Local Planning Panel

117 Victoria Street, Potts Point

D/2023/862

Proposal

15m height plane shown in red

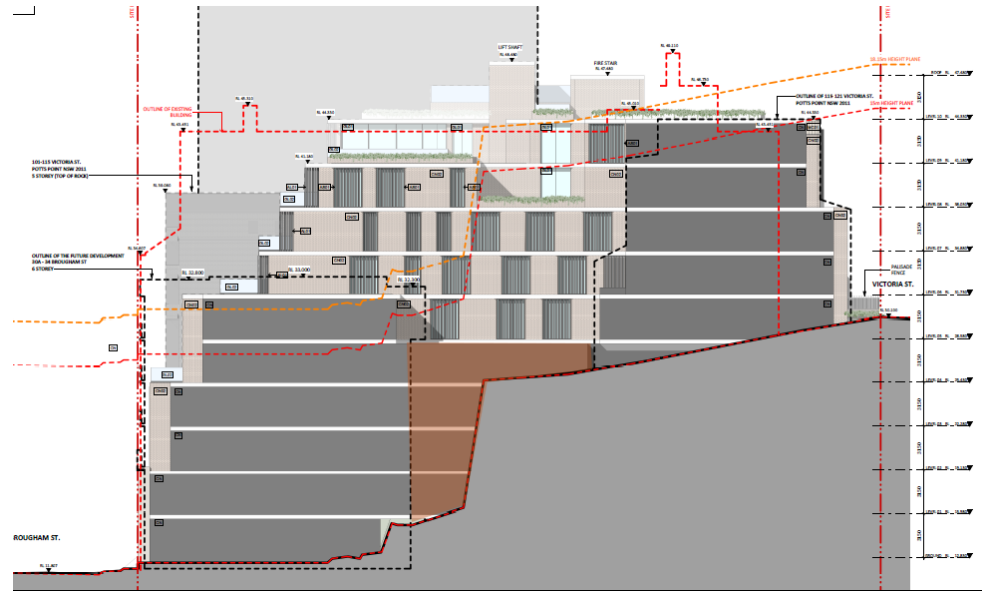
Height and FSR - bulk and scale

- 65.8% variation to 15m height control
- 20.8% variation to FSR control
- building not appropriately stepped with topography
